KANSAS CITY AREA TRANSPORTATION AUTHORITY

Invitation for Bids (IFB) #F23-5003-39A
Traction Power Substation – KC Streetcar Riverfront Extensions (Package 3)

ADDENDUM #2

Issue Date: February 7, 2023

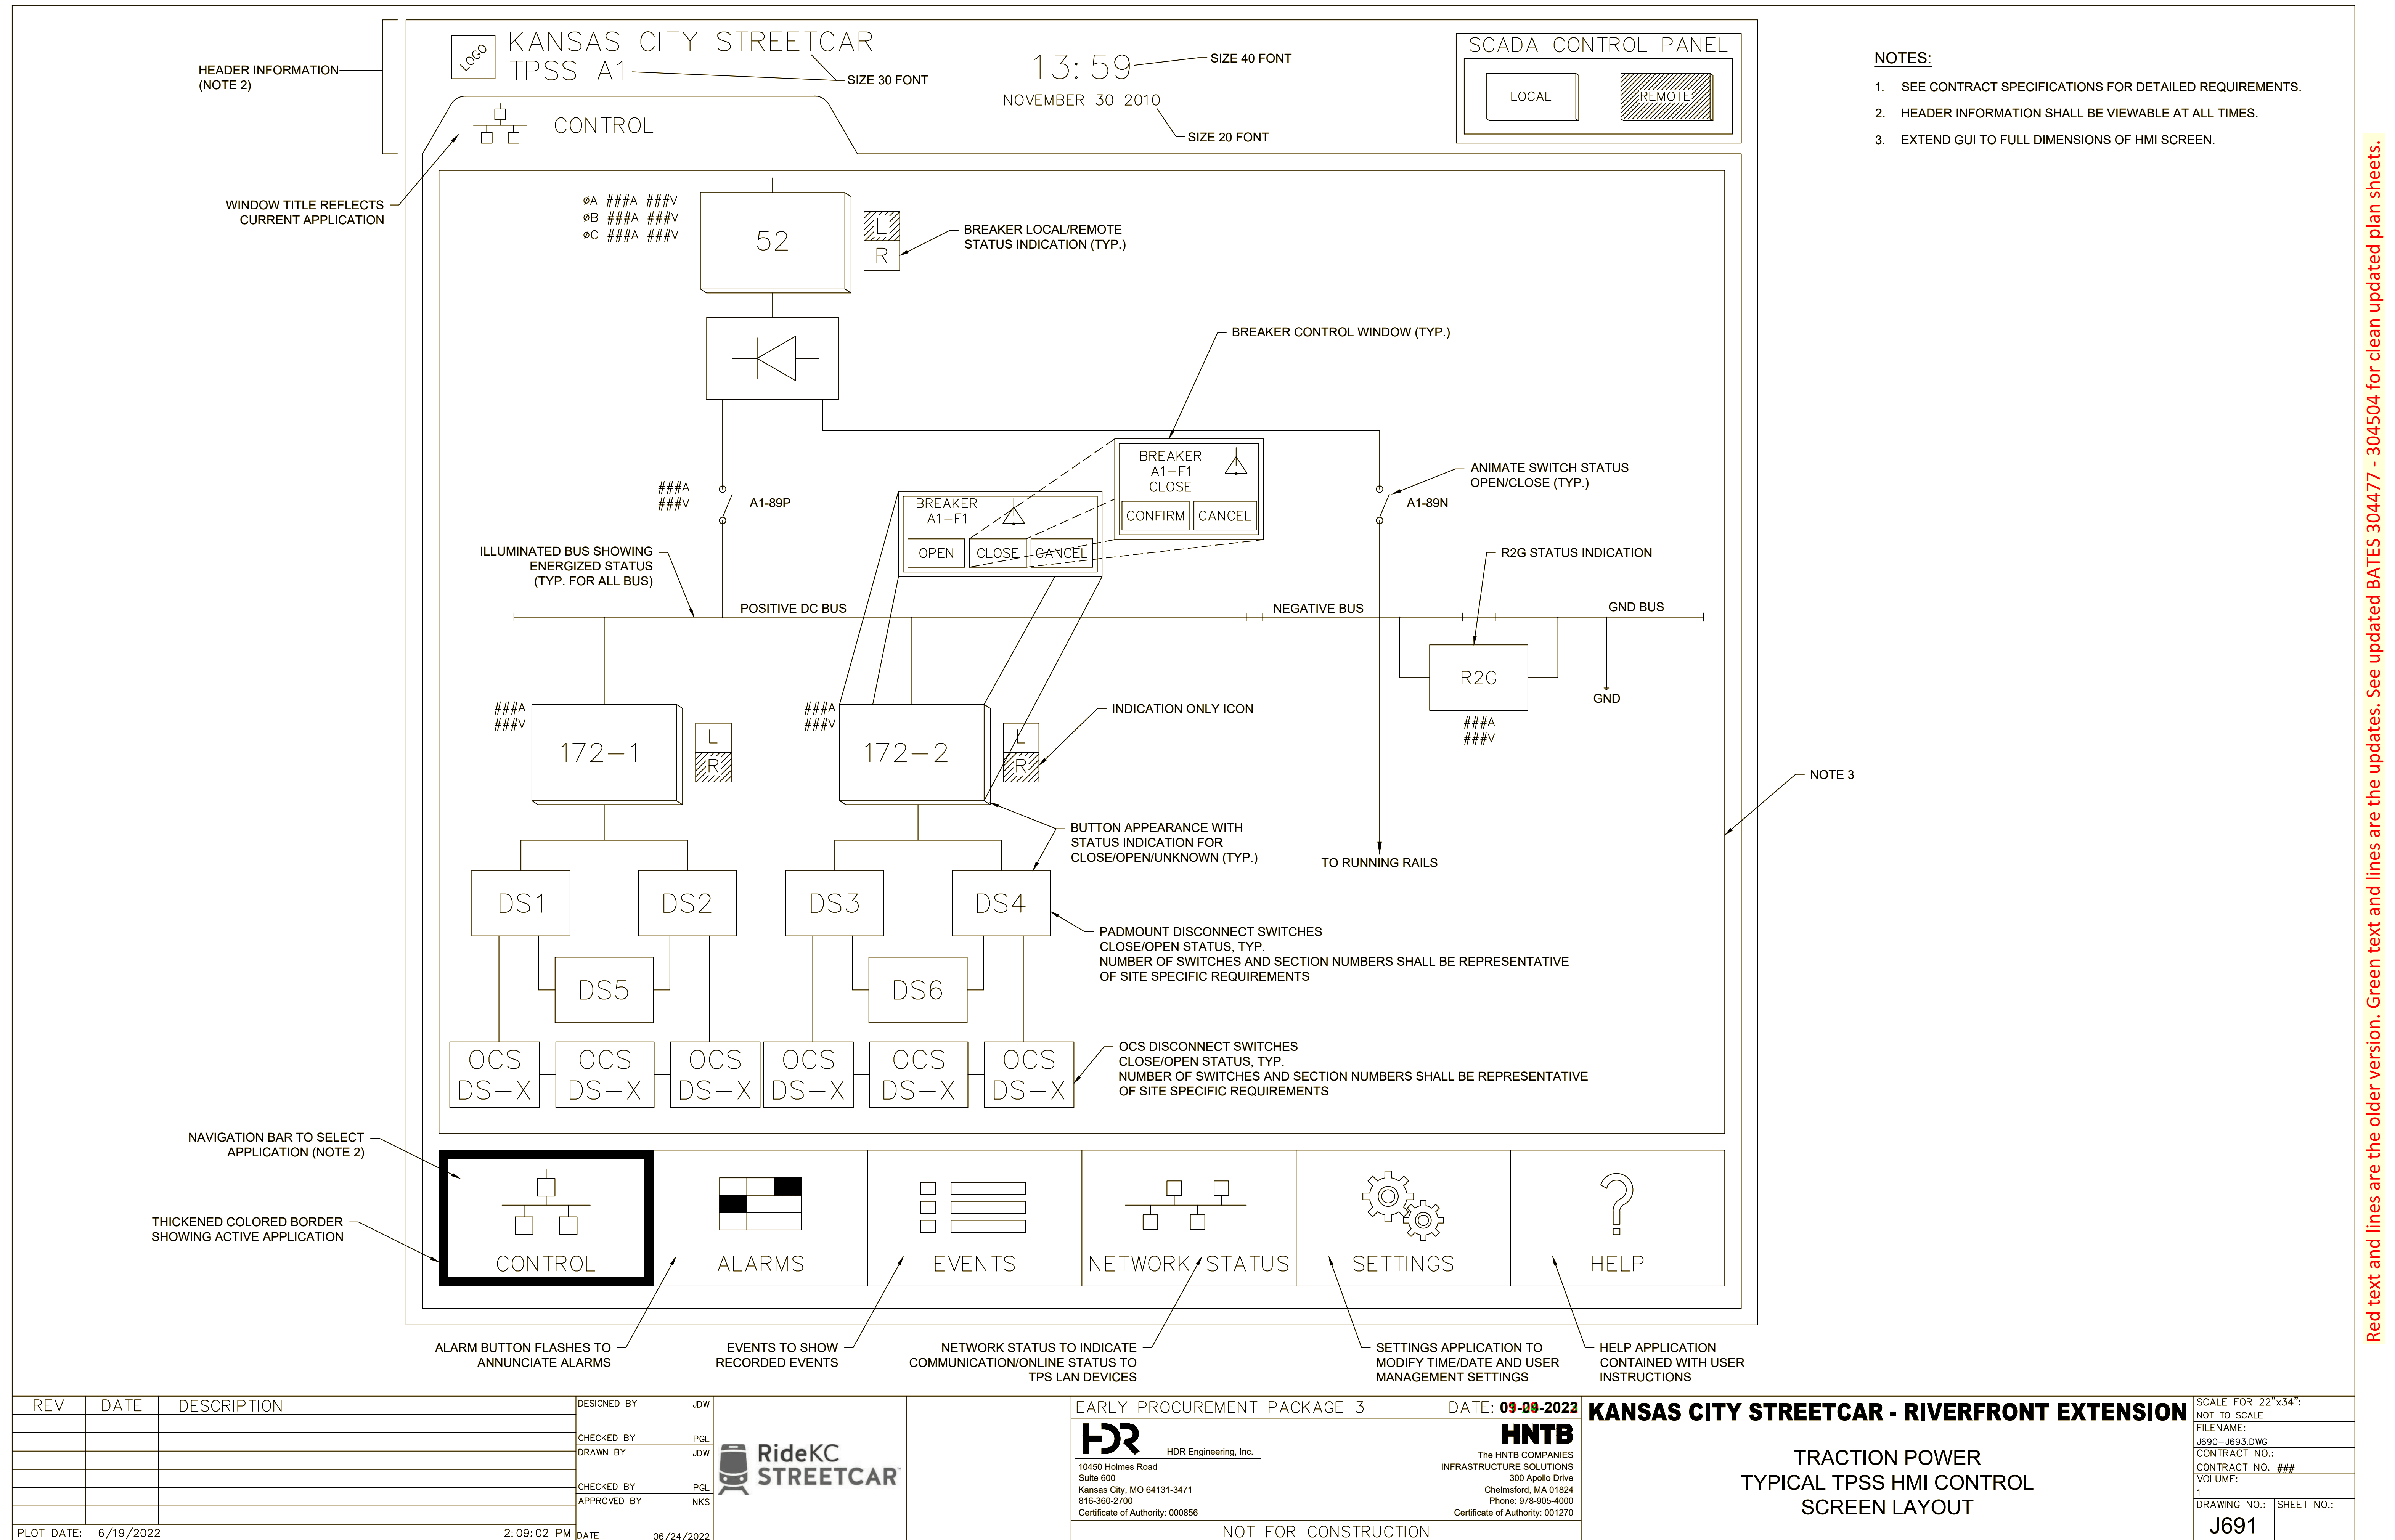
- Red text and lines are the older version. Green text and lines are the updates. See updated BATES 304477 - 304504 for clean updated plan sheets.
